Access Compliance Report Public Rights-of-Way (Curb Ramps)

Main Street: N/A Cross Street: ANDAZA_ST Location: NW

ADA ID: RPRK211203122400 Ramp Type: Type 4 - Parallel Initial Pass/Fail: Fail Overall Compliance: No Severity Score: 2

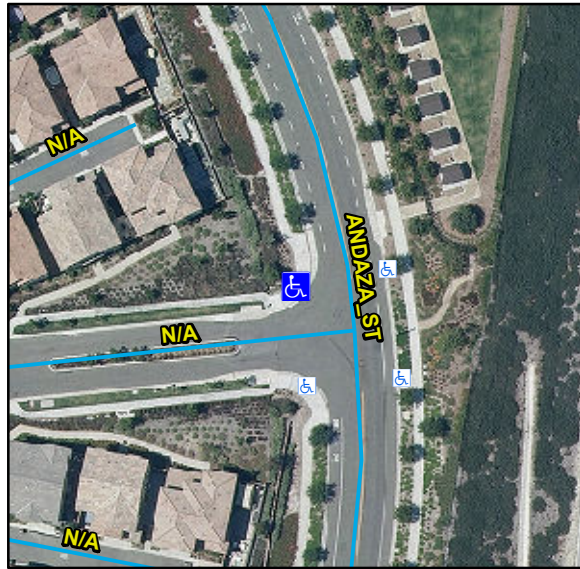
R304.5.3, STD 1115

Remove & Replace Curb Ramp With Two New Directional Ramps or Equivalent.
